# Access Compliance Report

## Public Rights-of-Way

Intersection ID: 25211	Main Street: SMITH_RD	Cross Street: SOUTHBRIDGE_FOREST_DR	Location: NE
ADA ID: 1DCD643CEE03	Ramp Type: Perp	Initial Pass/Fail: Fail	Overall Compliance: No
		Severity Score: 25

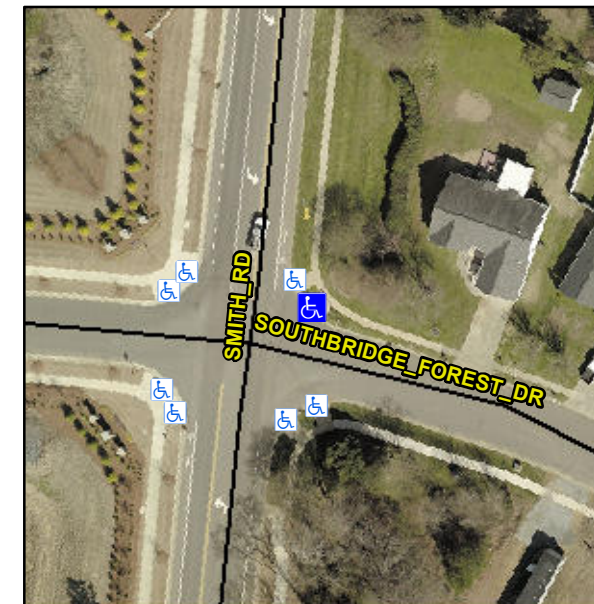
**Not Found, R304.2.2, R304.5.3**

Compliance	Description	Data	Compliance	Description	Data
N/A	Ramp Length (in)	102.0	No	Ramp Slope (%)	9.2
Yes	Ramp Width (in)	101.0	No	Ramp XSlope (%)	6.2
N/A	Flare Type LT	N/A	N/A	Flare Type RT	N/A
N/A	Flare Slope LT (%)	N/A	N/A	Flare Slope RT (%)	N/A
N/A	Flare Traversable LT?	N/A	N/A	Flare Traversable RT?	N/A
N/A	Landing Length (in)	N/A	N/A	DWS Provided?	N/A
N/A	Landing Width (in)	N/A	N/A	DWS Contrast?	N/A
N/A	Landing Slope (%)	N/A	N/A	DWS Length (in)	N/A
N/A	Landing X Slope (%)	N/A	N/A	DWS Full Width?	N/A
N/A	Landing Curb? (Y/N)	N/A	N/A	DWS Offset (in)	N/A
N/A	Shared Landing?	N/A			
N/A	Gutter Ponding?	N/A	N/A	Gutter Slope (%)	N/A
N/A	Gutter Lip Ht (in)	N/A	N/A	Gutter X Slope (%)	N/A
N/A	Painted X Walk1?	No	N/A	Painted X Walk2?	N/A
	X Walk 1 Direction	To SW		X Walk 2 Direction	N/A
N/A	X Walk 1 Width (in)	N/A	N/A	X Walk 2 Width (in)	N/A
	X Walk 1 Slope (%)	4.7		X Walk 2 Slope (%)	N/A
	X Walk 1 X Slope (%)	3.8		X Walk 2 X Slope (%)	N/A

**Remove & Replace Entire Ramp.**
